# UNITED STATES PATENT AND TRADEMARK OFFICE

APPLICATION NO.	FILING DATE	FIRST NAMED INVENTOR	ATTORNEY DOCKET NO.	CONFIRMATION NO.
10/791,741	03/04/2004	LaVern Alecci	04002	3613
23338	7590	12/15/2004	EXAMINER	
DENNISON, SCHULTZ, DOUGHERTY & MACDONALD 1727 KING STREET SUITE 105 ALEXANDRIA, VA 22314			GUADALUPE, YARITZA	
			ART UNIT	PAPER NUMBER
			2859

**Office Action Summary**

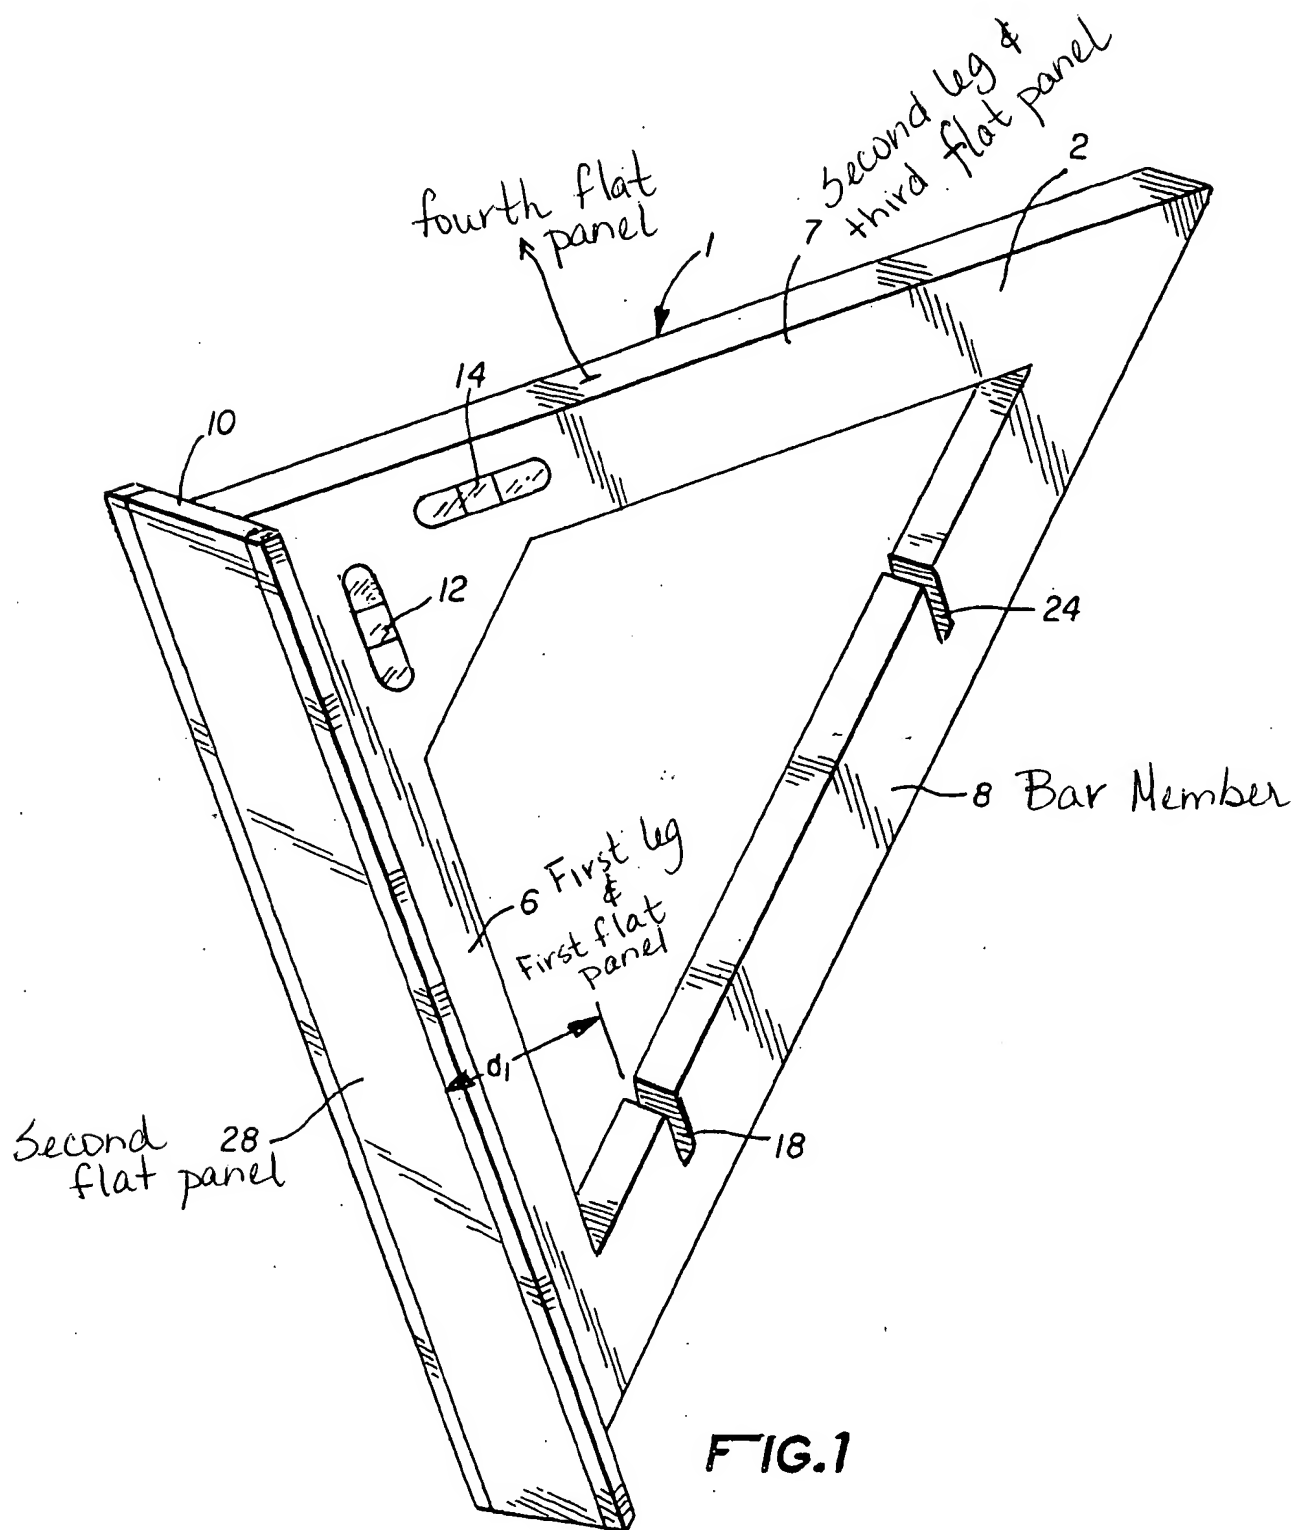
In regards to claims 1 and 8, Walters et al. discloses tool comprising a first leg (6); a second leg ( 7 ) attached to the first leg at an angle, i.e., 90 degree angle as shown in Figure 1; and, a plumb bob ( 22 ) attached to the plumb bob bracket tool by a string (20), ( See Figure 1 ).

With respect to claim 2, Walters et al. discloses a tool wherein said first leg ( 6 ) defines a first flat panel and comprises a second flat plat panel ( 28 ) attached to said first flat panel at a right angle ( See attached Figure 1 ).

In regards to claim 3, Walters et al. teaches a tool wherein said second leg ( 7 ) defines a third flat panel and comprises a fourth flat panel ( See attached Figure 1, wherein the surface adjacent to the leg is interpreted as said fourth flat panel ) attached to said third flat panel at a right angle.

Regarding to claim 4, Walters et al. discloses a tool further comprising a bar member ( 8 ) attached to said first flat panel at one end and said third flat panel at second end.

In regards to claims 1 and 9, in an alternate interpretation to the reference, Walters et al. discloses a tool comprising a first leg ( 7 ); a second leg ( 8 ) attached to the first leg at an angle, i.e., 45 degree angle as shown in Figure 1; and, a plumb bob ( 22 ) attached to the plumb bob bracket tool by a string (20), ( See Figure 1 ).
